SANITARY SEWER LAYOUT
LANKIN ADDITION
MAY, 1969
R.S. DELAMATER
CONSULTING ENGINEER
WICHITA, KANSAS

We are handing you herewith the tracings for the 48" storm sewer and the sanitary sewer which have been constructed to serve the Lankin Addition.

These tracings have been corrected to indicate the grades and dimensions as built and also to include the connecting lines into the sewers; in the case of the storm sewer we have indicated the location, flowline and grate elevation of the inlets which discharge into the manhole at the eastern end of the line.

48" STORM SEWER LAYOUT
LANKIN ADDITION
May, 1969
R.S. DELAMATER
CONSULTING ENGINEER
WICHITA, KANSAS

1 231-A-110

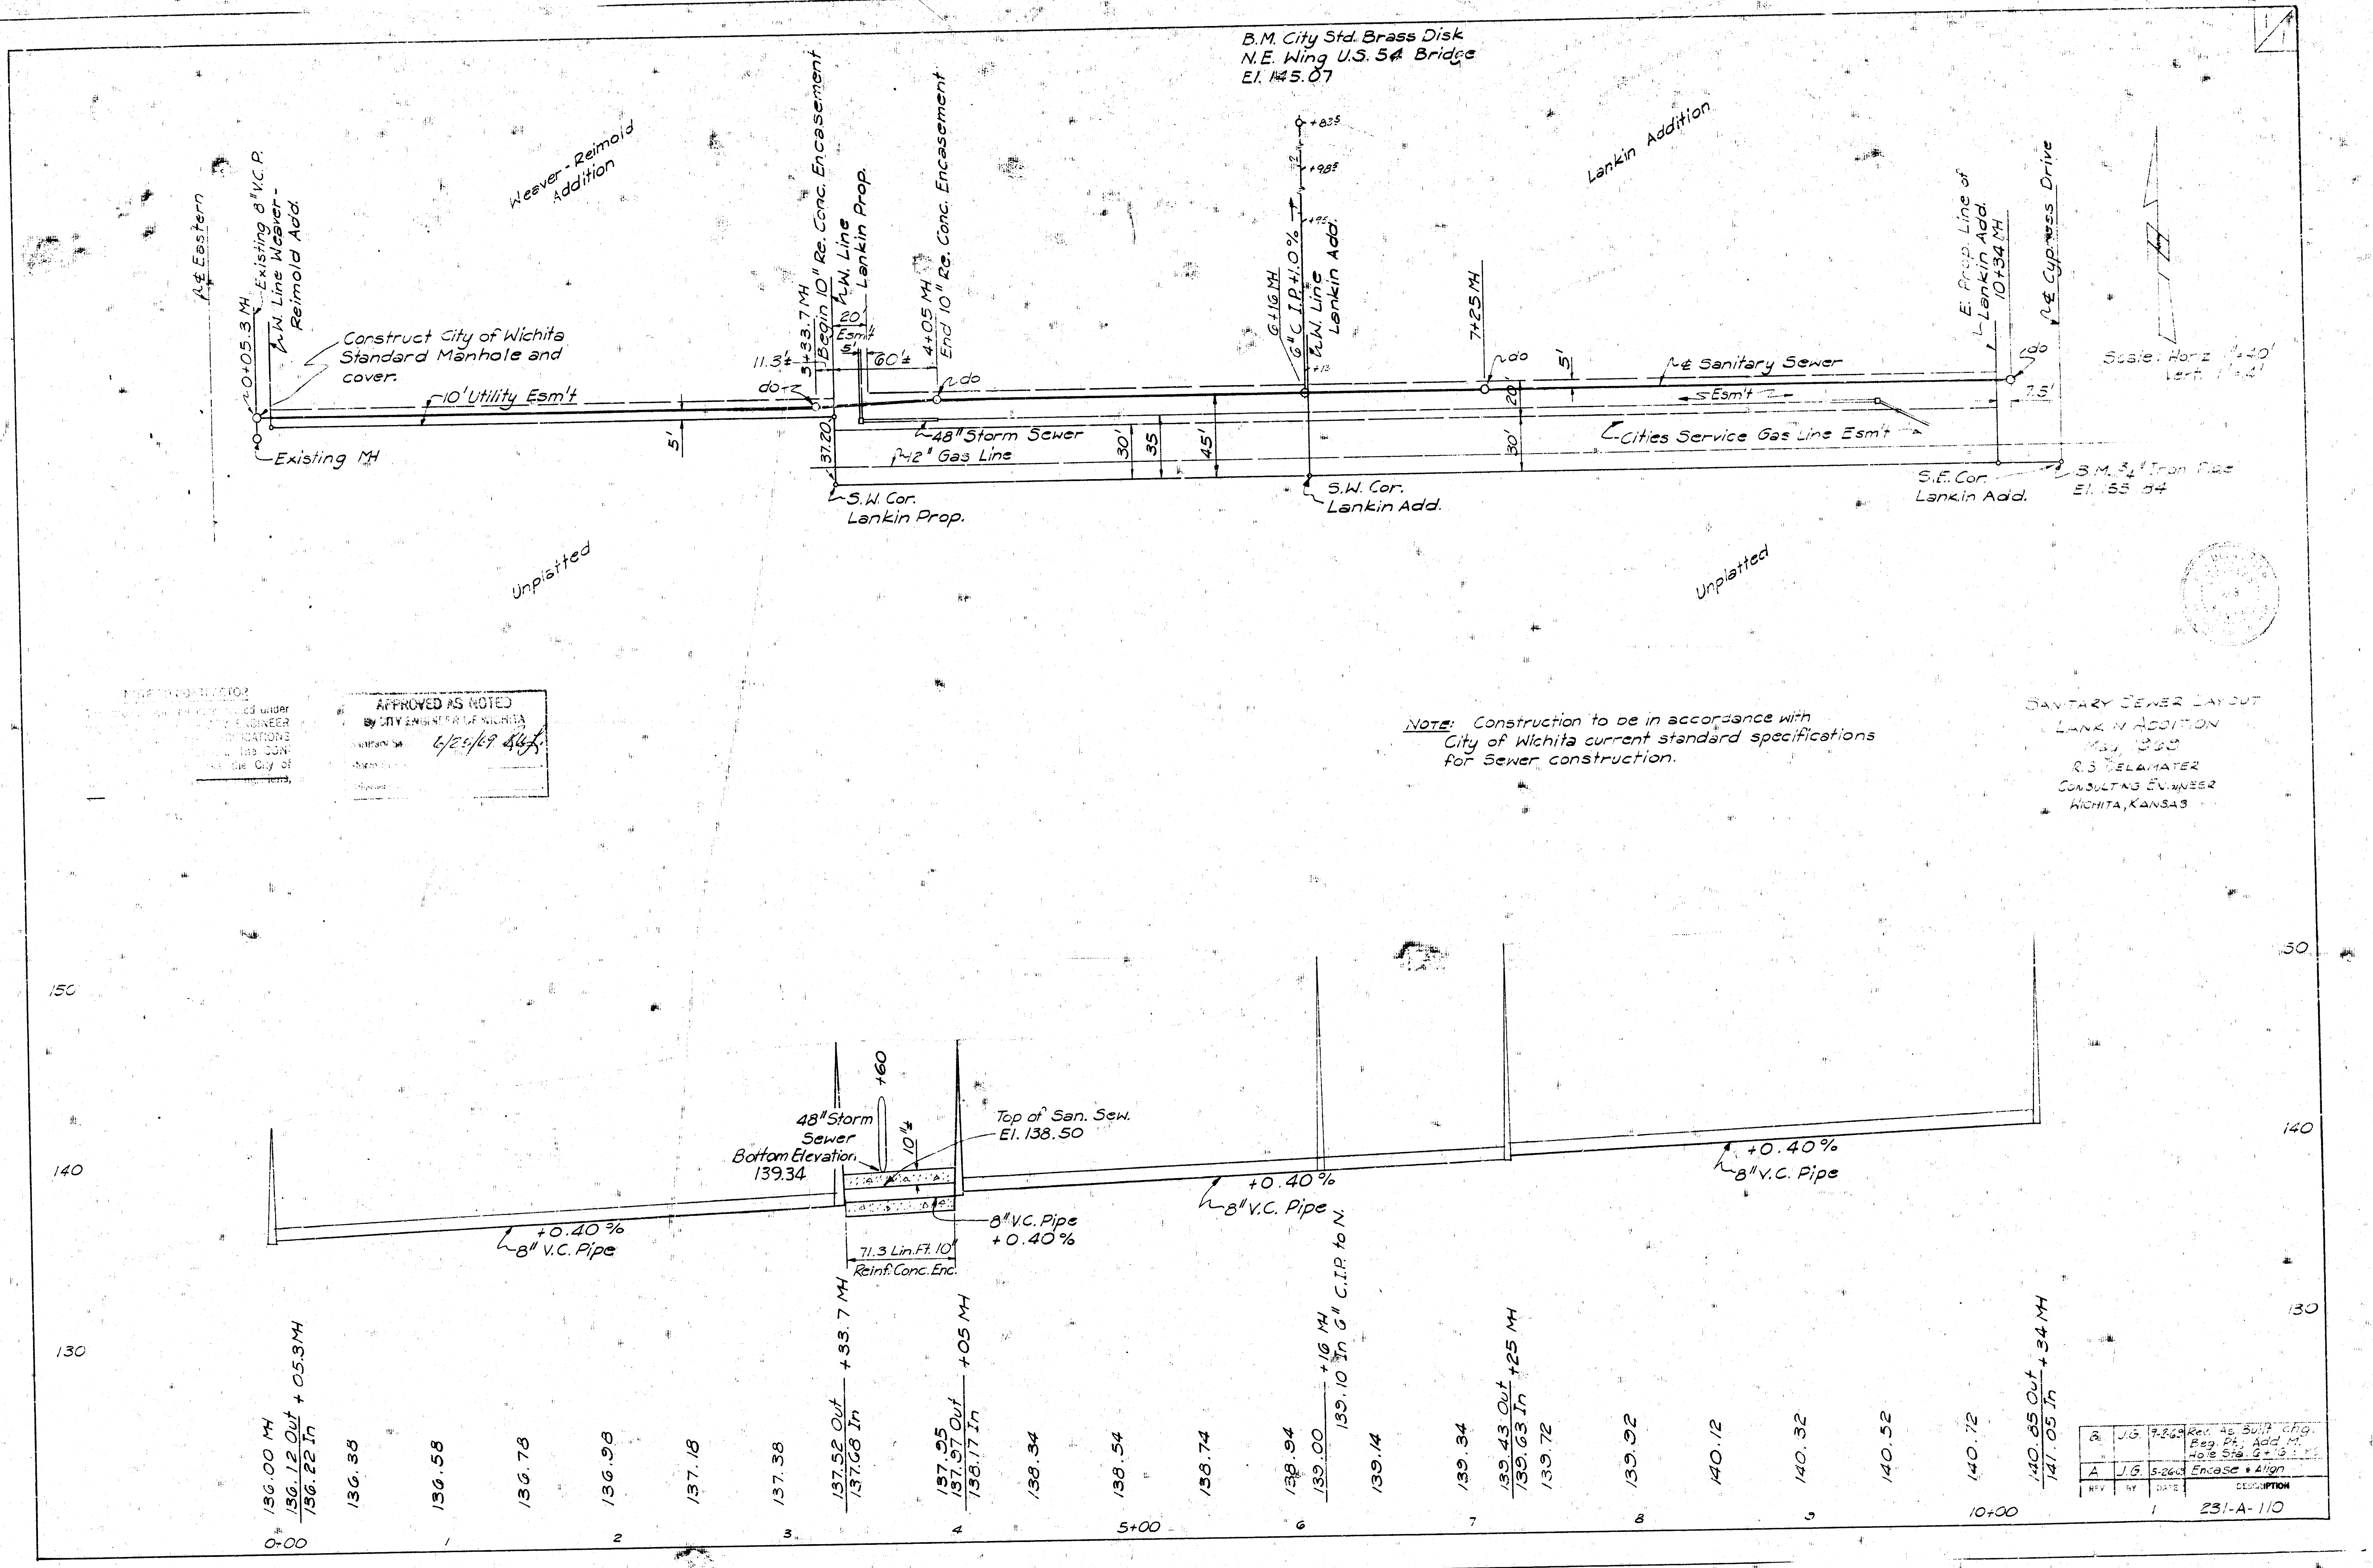
REV	BY	DATE	DESCRIPTION
B	J.G.	9-2-69	Rev. As Built chg. Beg. Pt.; Add M. Hole Sta. 6+16 ± MS
A	J.G.	5-26-69	Encase & Align

231-A-108

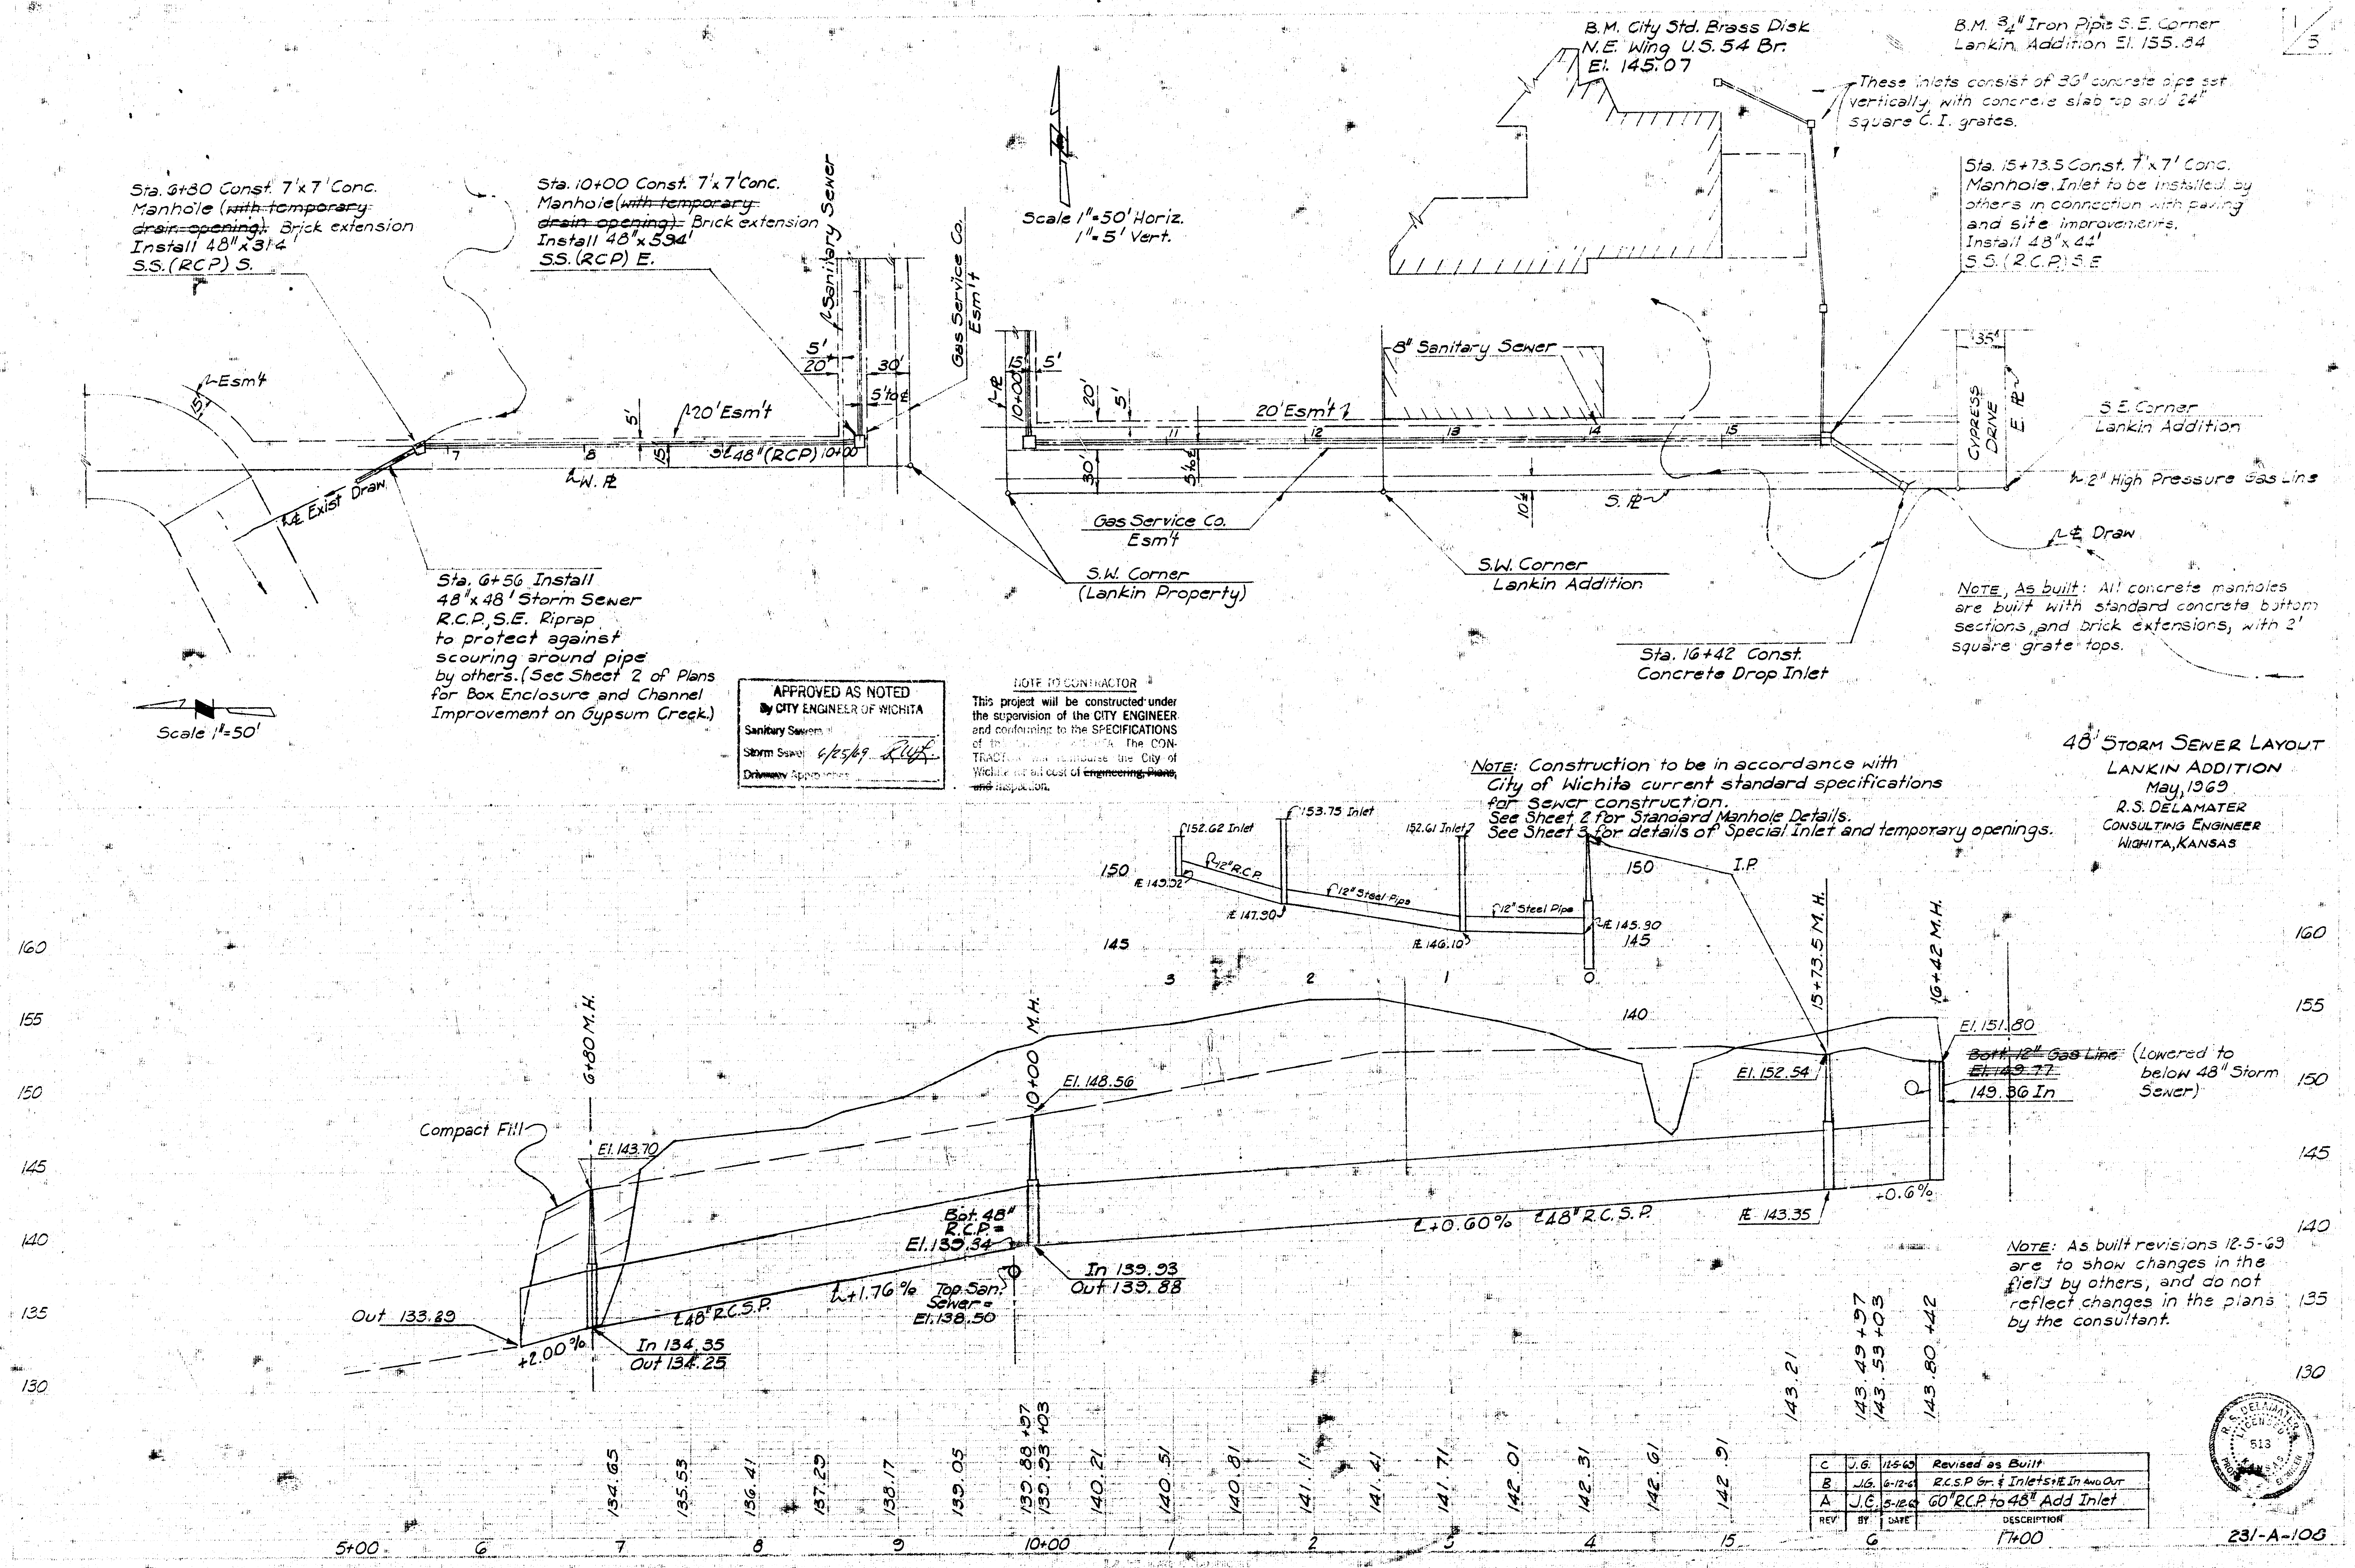
152.62 Inlet
153.75 Inlet
152.61 Inlet
12" R.C.P.
12" Steel Pipe
12" Steel Pipe
℄ 149.02
℄ 147.90
℄ 146.10
℄ 145.90
I.P.
160
155
150
145
140
135
130
3
2
1
0
6+80 M.H.
10+00 M.H.
15+73.5 M.H.
16+42 M.H.
Compact Fill
El. 143.70
El. 148.56
Bot. 48" R.C.P. = El. 139.34
In 139.93
Out 139.88
℄ +1.76%
Top San. Sewer = El. 138.50
℄ 48" R.C.S.P.
Out 133.29
+2.00%
In 134.35
Out 134.25
℄ +0.60%
℄ 48" R.C.S.P.
El. 152.54
℄ 143.35
+0.6%
El. 151.80
~~Bott. 12" Gas Line El. 149.77~~
(Lowered to below 48" Storm Sewer)

NOTE, As built: All concrete manholes are built with standard concrete bottom sections, and brick extensions, with 2' square grate tops.

NOTE: As built revisions 12-5-69 are to show changes in the field by others, and do not reflect changes in the plans by the consultant.

REV	BY	DATE	DESCRIPTION
C	J.G.	12-5-69	Revised as Built
B	J.G.	6-12-69	R.C.S.P Gr. & Inlets & ℄ In and Out
A	J.C.	5-12-69	60" R.C.P. to 48" Add Inlet
